Reply to the comments of Reviewer 2 (<https://doi.org/10.5194/essd-2021-72-RC2>) on the manuscript “LamaH | Large-Sample Data for Hydrology and Environmental Sciences for Central Europe” submitted to ESSD (<https://doi.org/10.5194/essd-2021-72>).

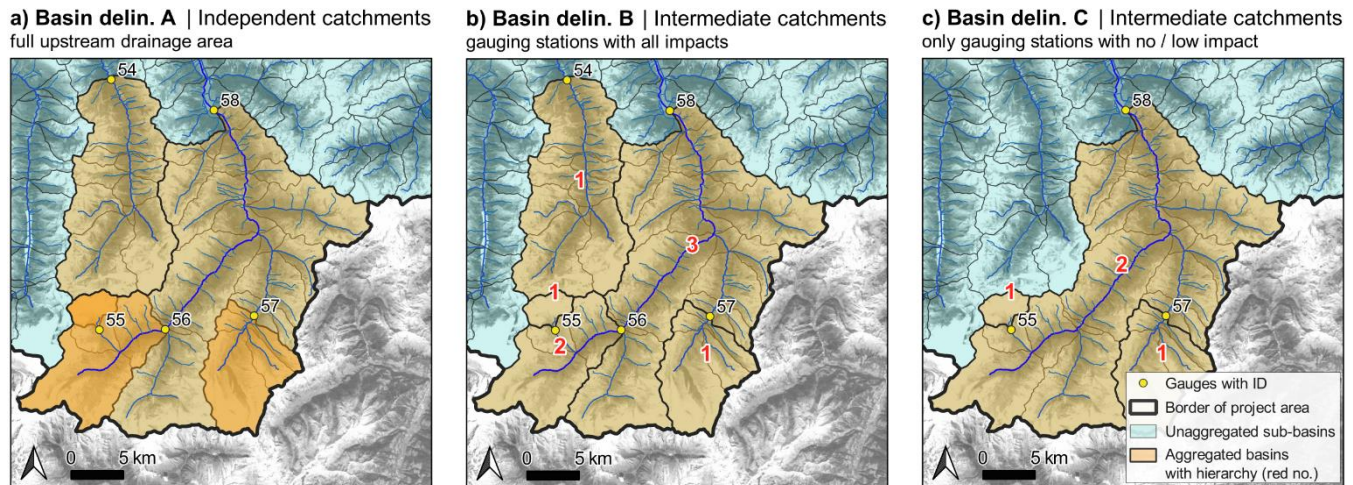
1.3 Figure 2. I find this figure a little unclear and the figure caption is currently very long. It may be worth simplifying the figure and thinking about moving some of the explanatory text in the figure caption to the main text in the paper.

Thank you for the suggestion. We propose to add a legend to the figure and to shorten the figure caption. We also increased the brightness of the background and hope that these adjustments will make it easier to understand the plot. We hope that these adaptations allow for a good understanding of the sub-basin aggregation, the catchment delineations and gauge hierarchy.

Fig. 3

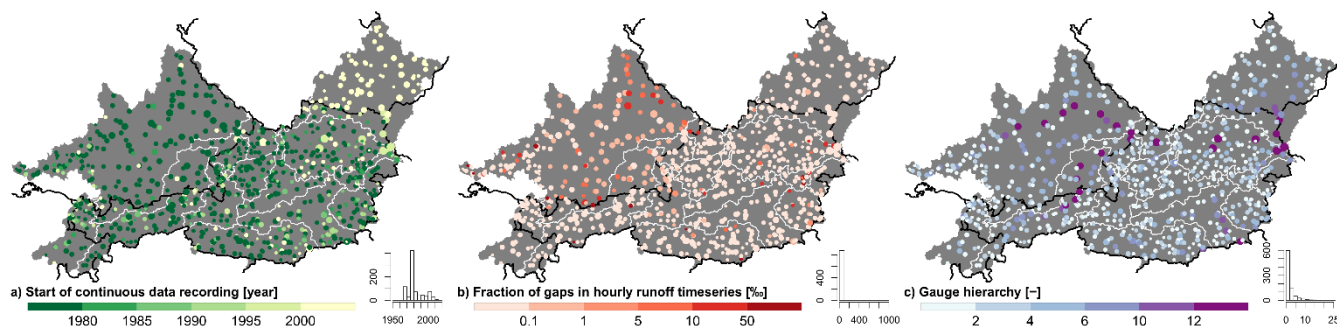
4. Colour scales. Often diverging colour scales are used for sequential data (for example Figure 3a and 3b). I encourage the authors to change the colour scales on these plots to sequential colour scales as this is a more appropriate colour scale for

15. Fig 3. *Figure 3a legend title should be ‘Start of continuous data record’. I also think the x-axis on the histogram in Figure 3b is incorrect – should go from 0 – 100%?*

Thank you for your suggestion. We have changed the color scales from diverging to sequential for the following plots and adapted the caption of Fig 3a according to your suggestion:

Caption of Figure 3a was changed, see our answer at 4). The fraction of gaps in each runoff time series (Figure 3b) are plotted in [%]. In Fig. 3b the last class is set to >50% because only few gauges have more than 50% gap fraction in their time series.

Fig. 1

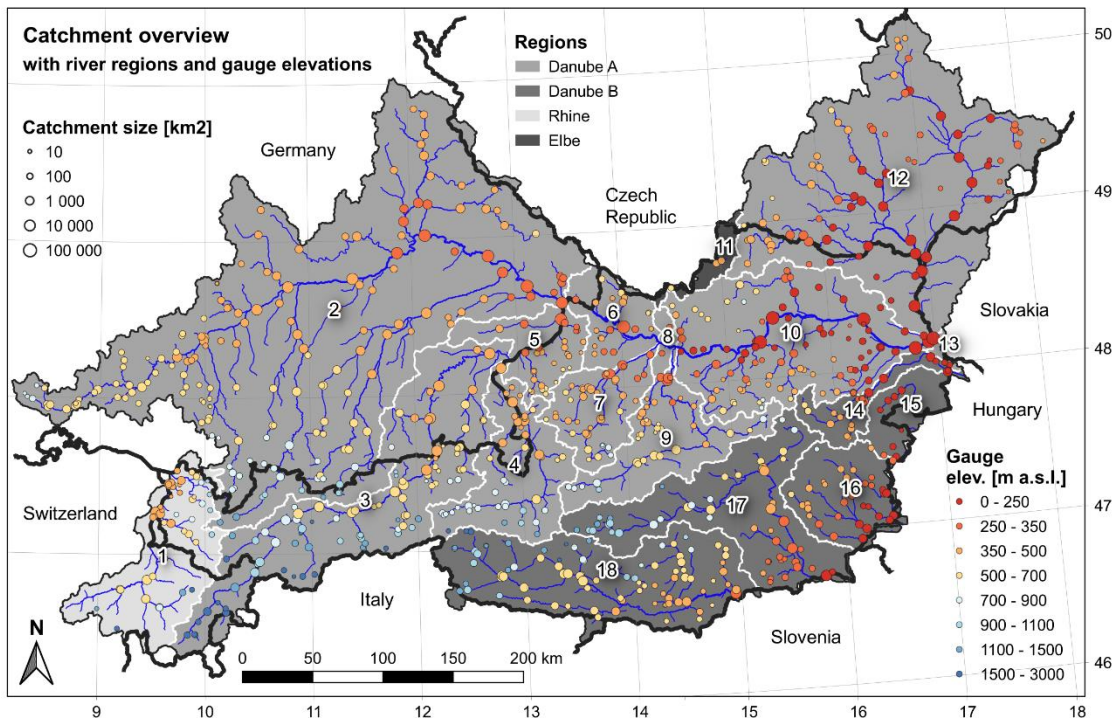
9. Figure 1. Can you add the size of the circle to the legend in the plot making it clear how the circle size relates to catchment area?

Thank you for your suggestion. We have added a legend to the figure. Reviewer 1 has suggested to highlight the macro- river region (i.e. Danube A, Danube B, Rhine and Elbe). Water from river regions declared with “Danube B” join the Danube outside Austria.
